RE: Planning Board and Public Questions
Proposed DAN8 Last Mile Delivery Station – 232 State Route 30A, Schoharie, NY

We are in receipt of the Planning Board and public questions asked during the July 15, 2025 Planning Board Meeting, prepared by the Planning Board Secretary. We are pleased to submit the following response to questions in association with our Site Plan Amendment application for the above referenced project located at 232 State Route 30A, Schoharie, NY. All sheets referenced in the responses below are included in the updated package of engineered site plans submitted to the Planning Board on August 14, 2025.

1 OVERALL GROUND FLOOR PLAN

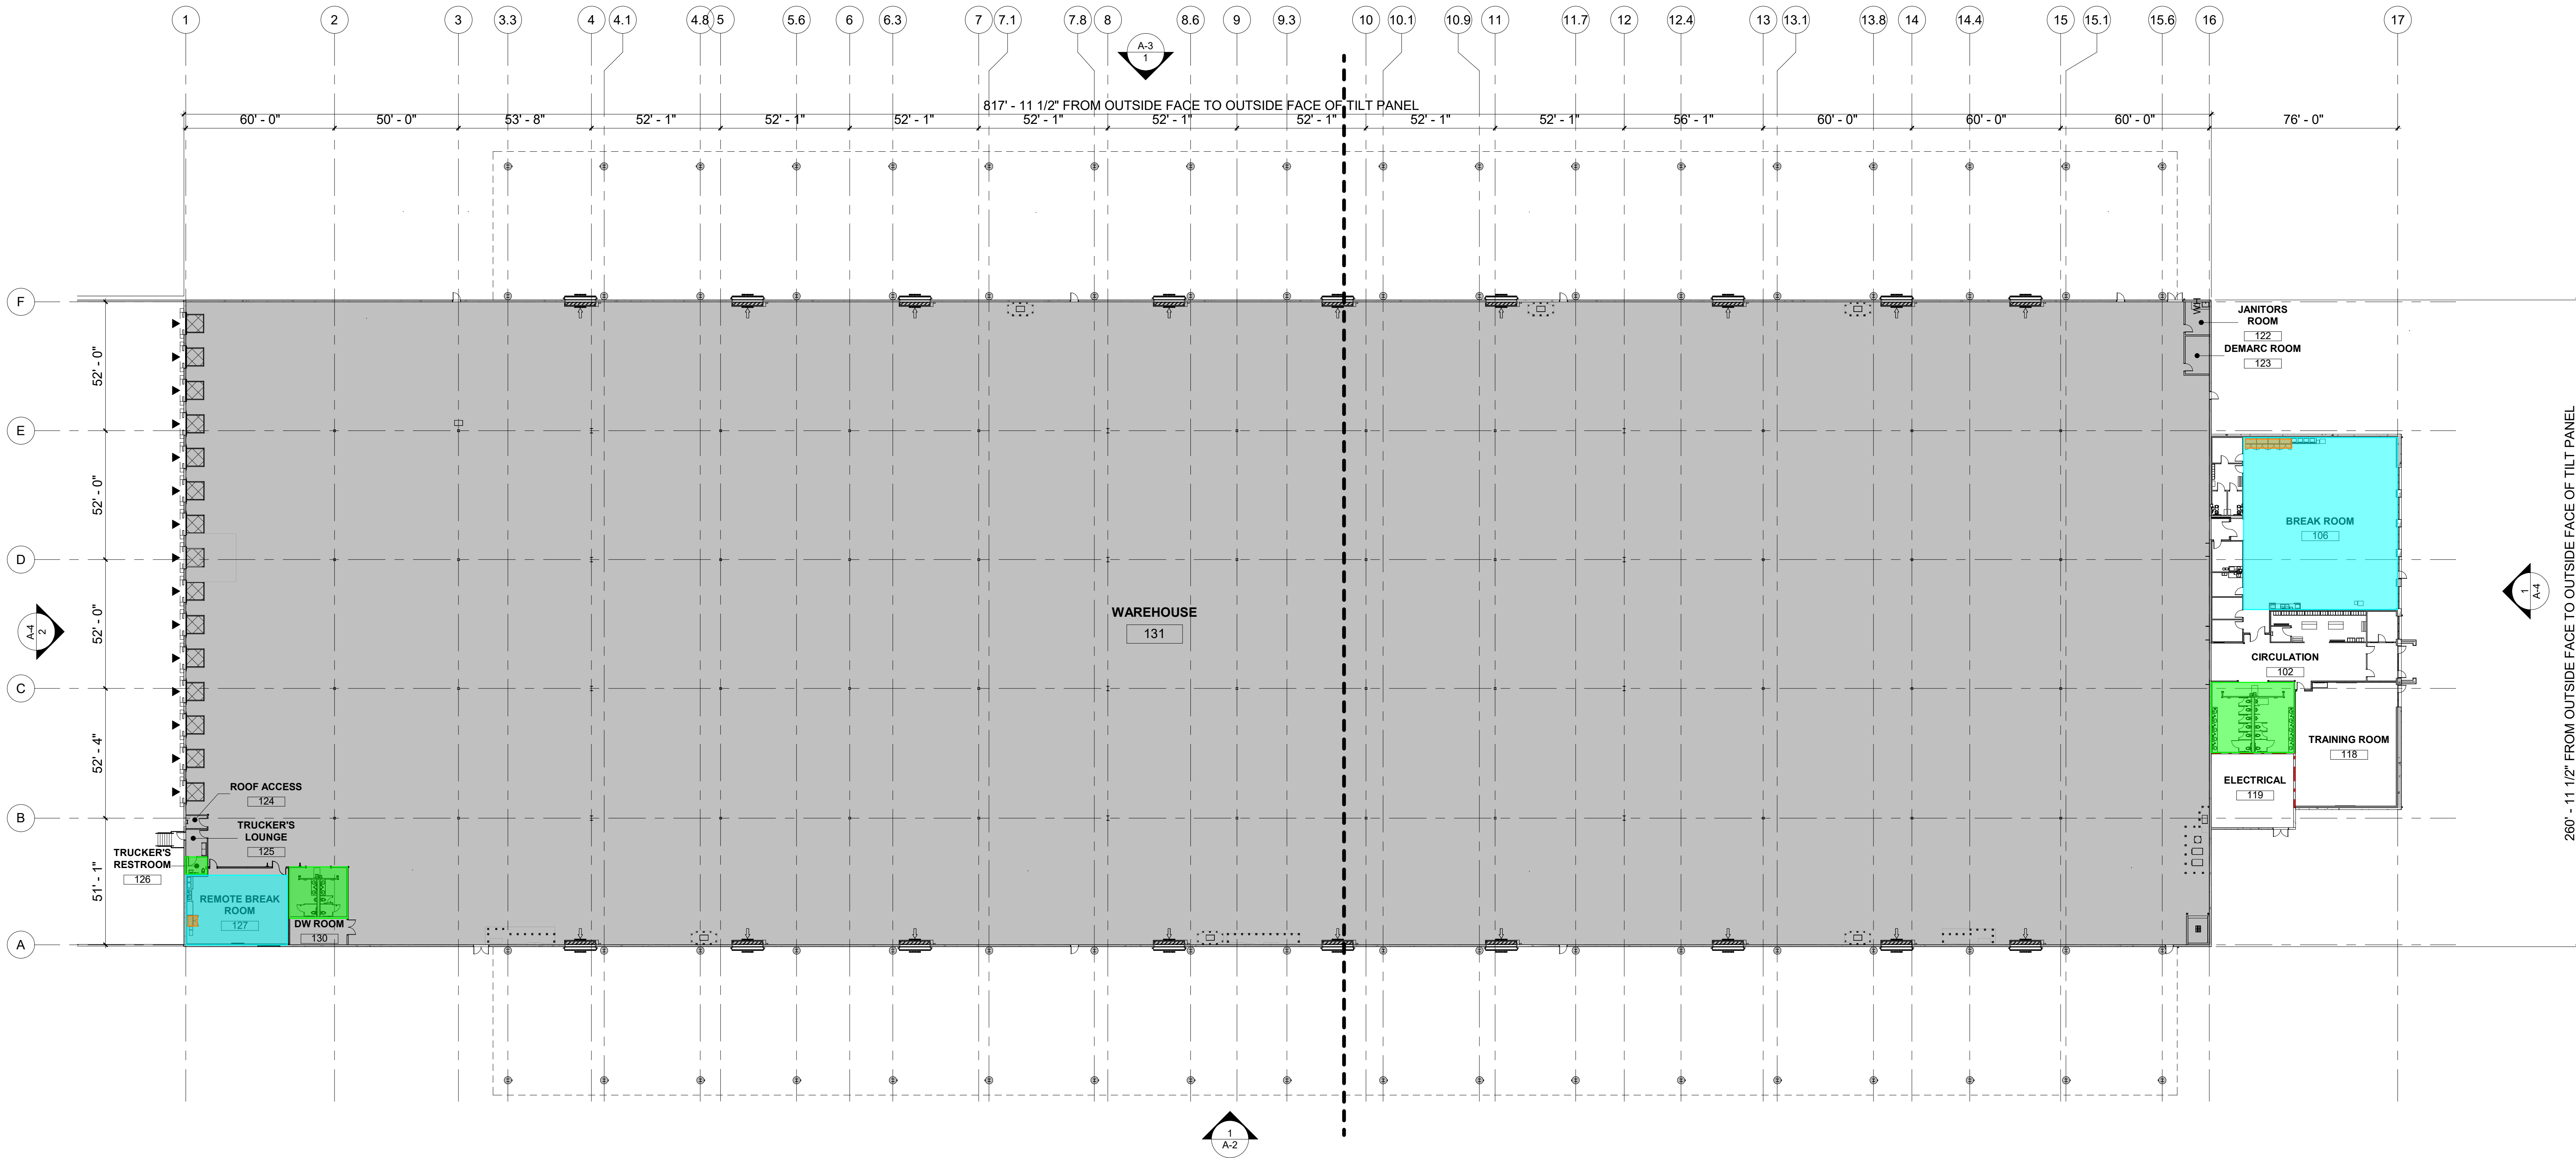
13. Where are the break room locations?

14. Is there refrigeration offered in break room?

15. What is the number of bathrooms?

Response: The Remote Breakroom is located in the "Plan Southwest" portion of the building. The Main Breakroom is located in the "Plan East" portion of the building. (See attached floor plan in green).

Response: Yes, refrigeration is offered in both breakrooms. (See attached floor plan in orange).

Response: There are 5 total restrooms throughout building. (See attached floor plan in blue).
